Docket Item # 10  
BAR CASE # 2008-0116

**ISSUE:** Waiver of Rooftop HVAC Screening

**LOCATION:** 532 N. Washington Street

**BAR CASE #2008-0114,0115,0116 9/17/2008**

Figure 1. Proposed roof plan.

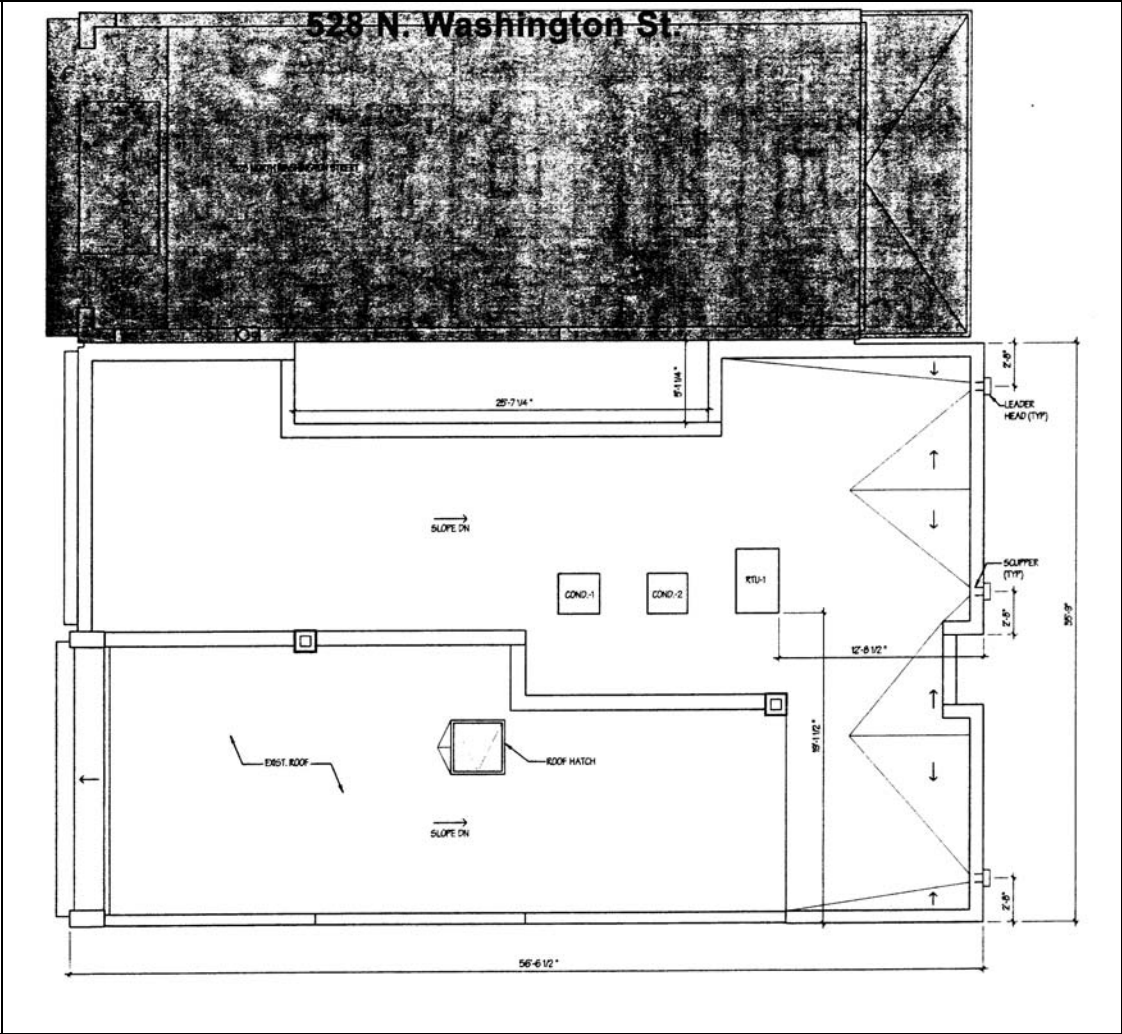
The applicant is requesting a Waiver of Rooftop HVAC Screening Requirement for 532 North Washington Street. The HVAC equipment is proposed to be located on the proposed addition at 532 North Washington Street. The proposed roof plan indicates the placement of three HVAC units on the middle portion of the addition.

Figure 2. Sight line of HVAC equipment across Pendleton Street.

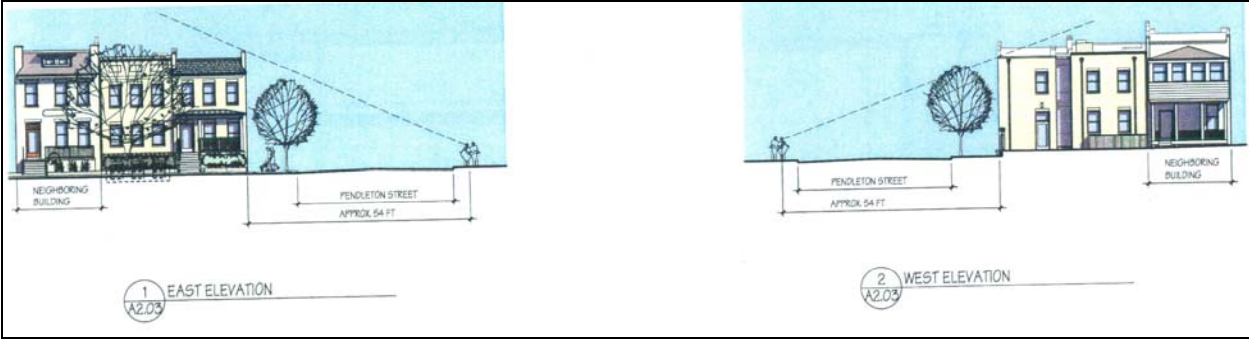
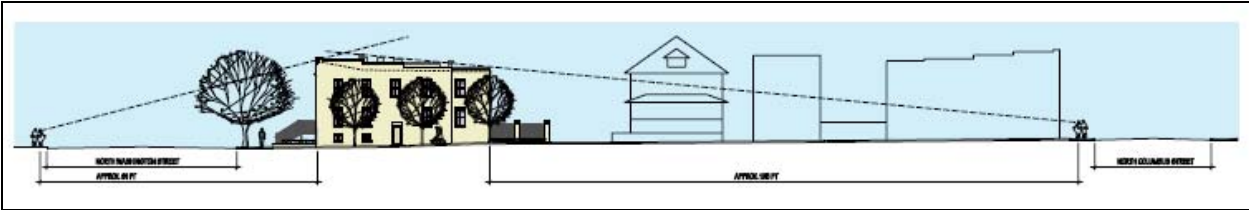
When considering the request for a Waiver of Rooftop HVAC Screening Requirement, one must consider the visibility of the HVAC equipment and/or screening from the public right-of-way. The *Design Guidelines* advise that “HVAC equipment should be located in a visually inconspicuous area of a building” and that “HVAC equipment should not disrupt the architectural character of a structure.” Staff finds that the proposed placement of the rooftop HVAC units will be minimally visible from the public right-of-way. The applicant has submitted sight lines that illustrate the minimal visibility of the proposed rooftop equipment.

Staff recommends painting the equipment in a color that will further allow the equipment to recede. Staff notes that in certain circumstances screening can actually increase the visibility of the rooftop equipment. Staff has no objections to the proposed Waiver of Rooftop Screening Requirement should the Board approve the Certificate of Appropriateness for the infill construction.
